# Access Compliance Report

## Public Rights-of-Way

Intersection ID: 43642	Main Street: CEDAR_CROSSINGS_DR	Cross Street: HUNTINGTON_MEADOW_LN	Location: SW
ADA ID: CC712210FAC4	Ramp Type: PerpDiag	Initial Pass/Fail: Fail	Overall Compliance: No
Codes/Mitigation Info/Possible Solution			Severity Score: 35
			Field Measurements/Component Compliance

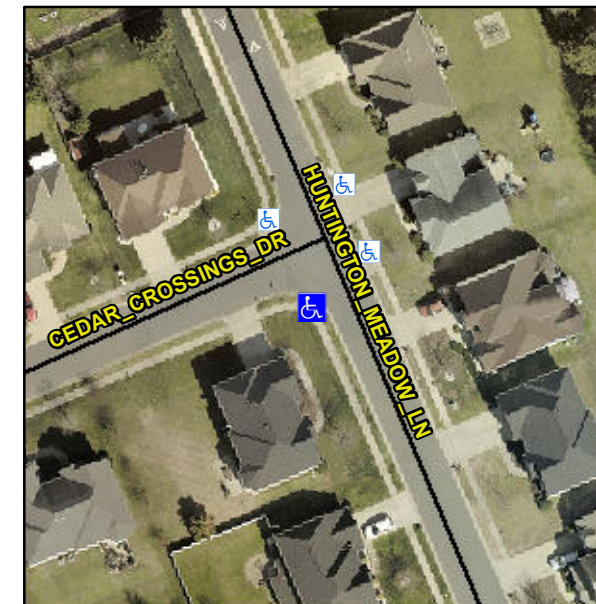
**Not Found, R304.5.1, R304.2.2, R304.5.3**

Compliance	Description	Data	Compliance	Description	Data
N/A	Ramp Length (in)	48.0	No	Ramp Slope (%)	13.8
No	Ramp Width (in)	40.0	No	Ramp XSlope (%)	2.6
N/A	Flare Type LT	N/A	N/A	Flare Type RT	N/A
N/A	Flare Slope LT (%)	N/A	N/A	Flare Slope RT (%)	N/A
N/A	Flare Traversable LT?	N/A	N/A	Flare Traversable RT?	N/A
N/A	Landing Length (in)	N/A	N/A	DWS Provided?	N/A
N/A	Landing Width (in)	N/A	N/A	DWS Contrast?	N/A
N/A	Landing Slope (%)	N/A	N/A	DWS Length (in)	N/A
N/A	Landing X Slope (%)	N/A	N/A	DWS Full Width?	N/A
N/A	Landing Curb? (Y/N)	N/A	N/A	DWS Offset (in)	N/A
N/A	Shared Landing?	N/A			
N/A	Gutter Ponding?	N/A	N/A	Gutter Slope (%)	N/A
N/A	Gutter Lip Ht (in)	N/A	N/A	Gutter X Slope (%)	N/A
N/A	Painted X Walk1?	No	N/A	Painted X Walk2?	No
	X Walk 1 Direction	To E		X Walk 2 Direction	To N
N/A	X Walk 1 Width (in)	N/A	N/A	X Walk 2 Width (in)	N/A
	X Walk 1 Slope (%)	3.3		X Walk 2 Slope (%)	0.9
	X Walk 1 X Slope (%)	2.0		X Walk 2 X Slope (%)	1.7

**Remove & Replace Curb Ramp With Two New Directional Ramps or Equivalent.**
